AMENDMENTS TO THE DRAWINGS

REMARKS

This amendment is responsive to the Office Action dated October 20, 2008. Claim 1 is currently amended. New claim 3 has been added. Support for these amendments may be found variously throughout the Specification, for example on page 9, lines 26 – page 12, line 13. *These amendments add no new matter.* In the amendment, claim 1 remain pending in the application. Reconsideration and allowance of the pending claims are respectfully requested.

Fig.1

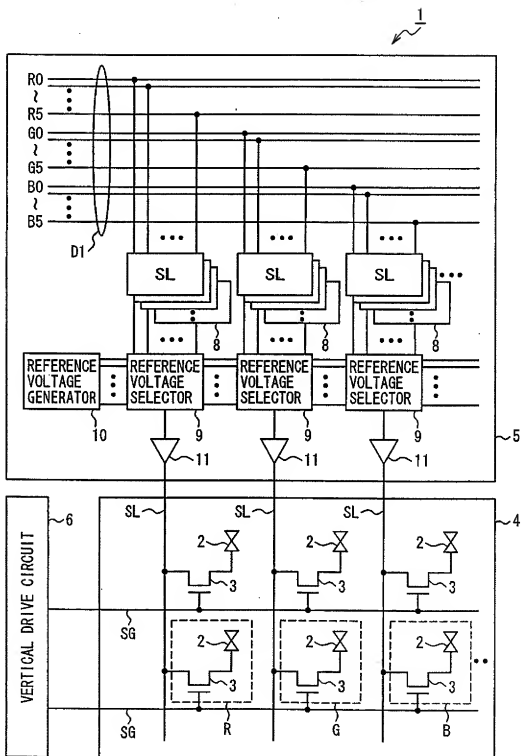
The attached sheets of drawings include changes to FIGS. 1, 2, and 3 labeling FIG. 1, FIG. 2, and FIG. 3 as --BACKGROUND ART-- as described in the pages 1-6 of the Specification. Additionally, reference characters "Lout_(Inv)" and "Lout_(Non-inv)" have been added to distinguish the inverted and non-inverted Lout as shown in FIGS. 2, 3, and 4, as described in page 5, line 21 – page 6, line 17 and page 11, line 24 – page 12, line 11. Also, "VSS-HVSS2" has been deleted from FIG. 4.

--BACKGROUND ART--

Fig.3
 -- BACKGROUND ART --

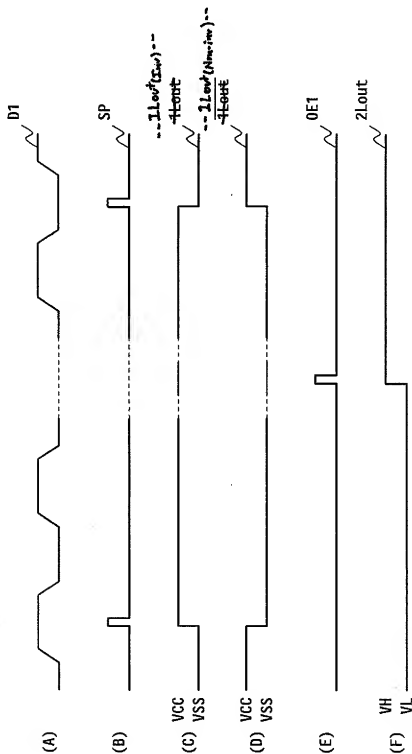
Additionally, while FIG. 3(C) and 3(D) discloses the inverted and non-inverted output voltages $1Lout_{(Inv)}$ and $1Lout_{(Non-inv)}$ rising and falling with timing SP, AAPA clearly fails to disclose or suggest “*raising a power supply voltage of said first latch section from a first voltage to a second voltage while said first latch result is transferred to said second latch section[.]*”
